Service Action: Drive Module Harness Edge Protection

I12 (i8)

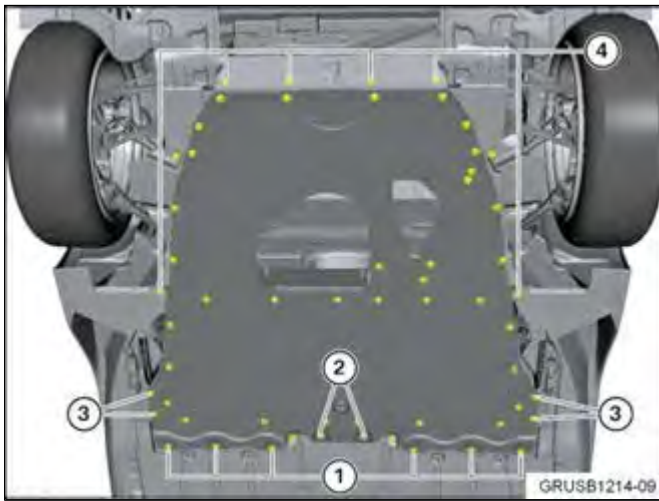
3. Cut the edge protection into two pieces, 200 mm (approximately 8") long.
4. Secure each edge protection piece to the Carbon Fiber (CFRP) flanges above and below the ISOFIX mount, as shown in red. This is located on the rear bulkhead of the vehicle.

NOTE: The CFRP flange is very sharp, so gloves should be worn for this step.

5. Secure the wire tie retaining clip to the plastic DME bracket as shown.
6. Secure the wire tie to the corrugated tube.

7. Verify the installation as shown, which includes:
 - Corrugated tubing already present – yellow arrow
 - Edge protection on flanges – red lines
 - Corrugated tube wire tied to the DME bracket – green circle
